# Service Bulletin

ISSUE NO. M-045

**SUBJECT** MODIFICATION OF CRANKSHAFT

**APPLICABLE MODEL** GT750

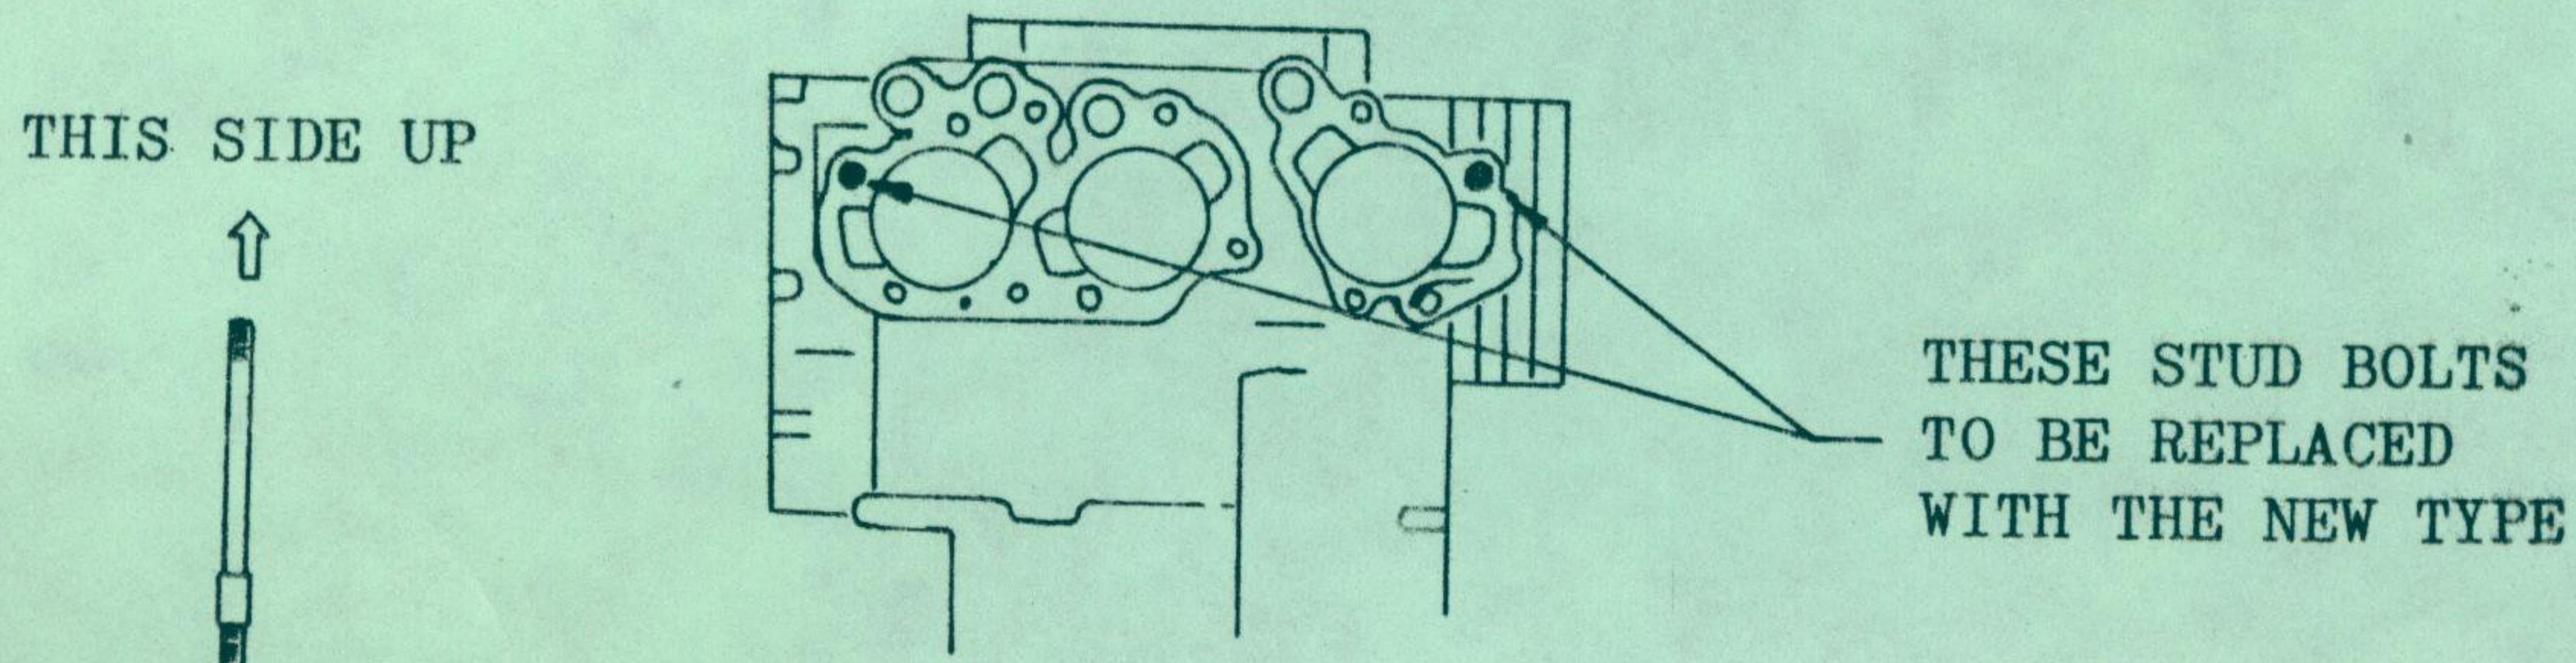
- 2) Replace two stud bolts shown below with those modified; the stud bolts have the cylinder locate in place on the crank case so that the center of the bore just aligns with that of the con-rod.

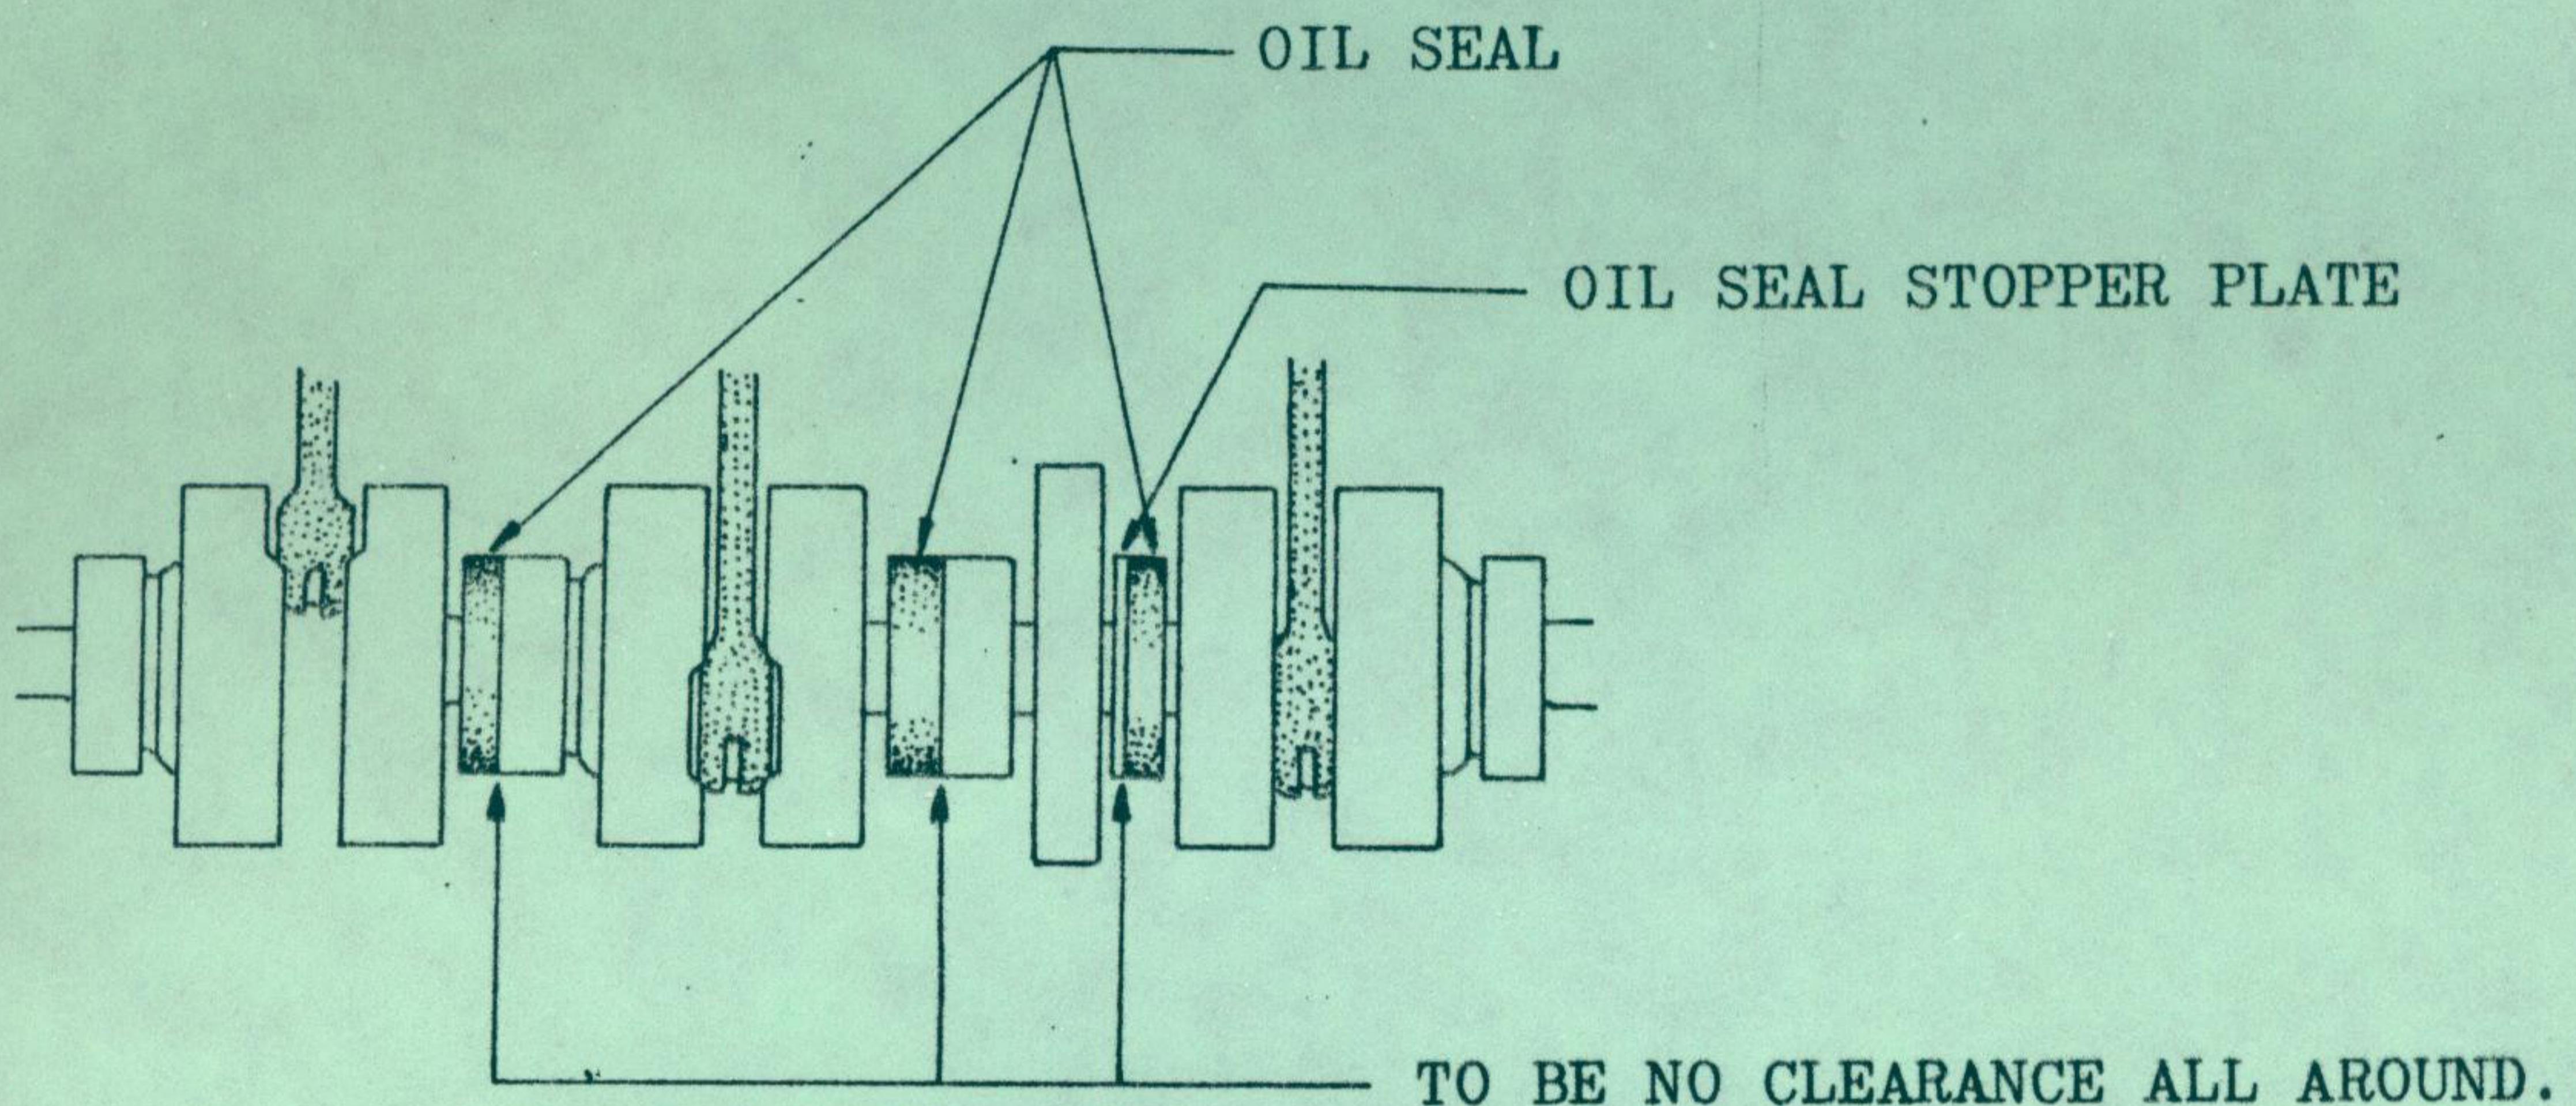
- 1) In placing the crankshaft on the crank case lower half, following instruction should be conducted in order to avoid gear box oil leakage to the crank camber.

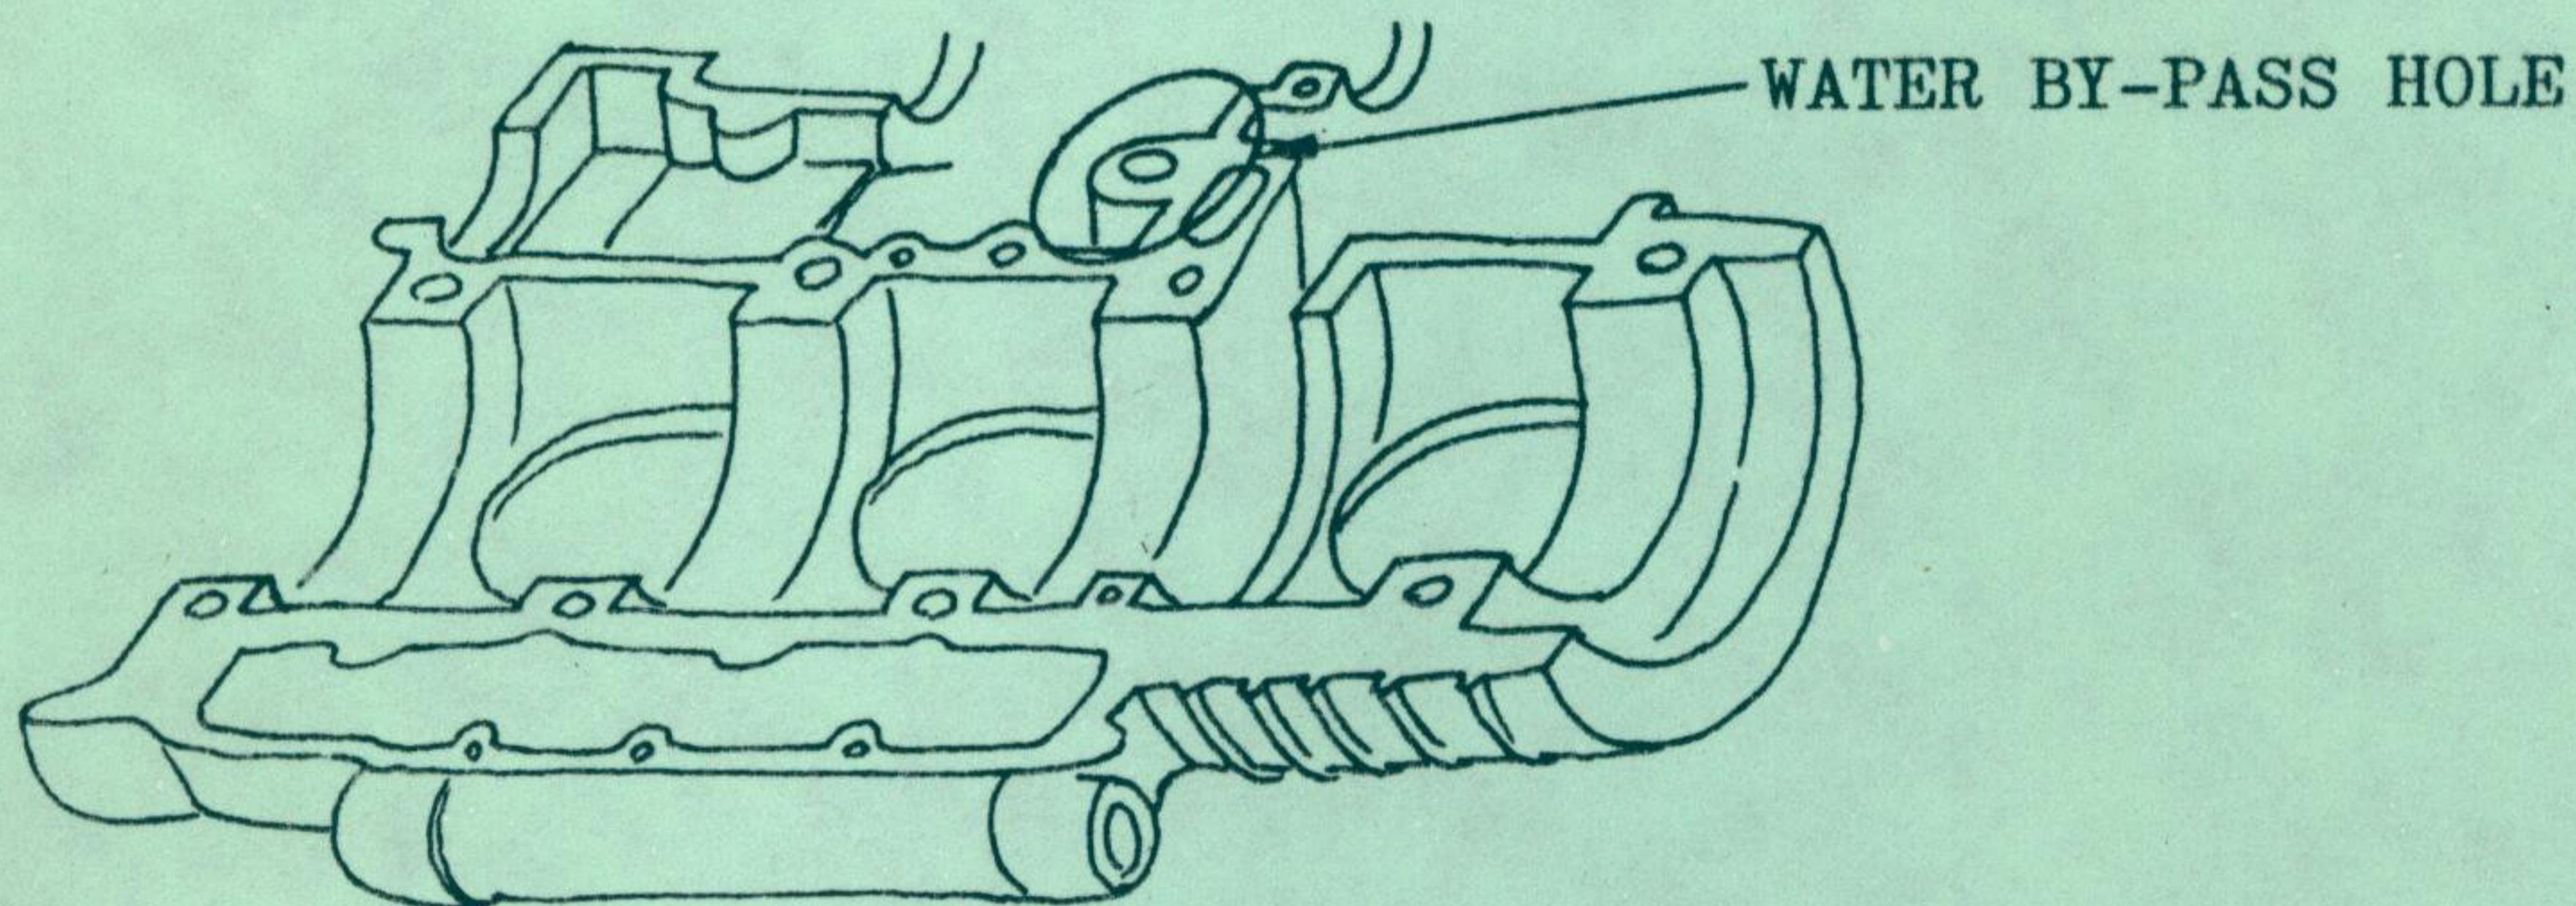
- 2) When coating SUZUKI BOND NO. 4 (99000-33030) for the crank case seal, be sure to apply it to the part of the water by-pass hole shown below in order to avoid water leakage to the gear box.
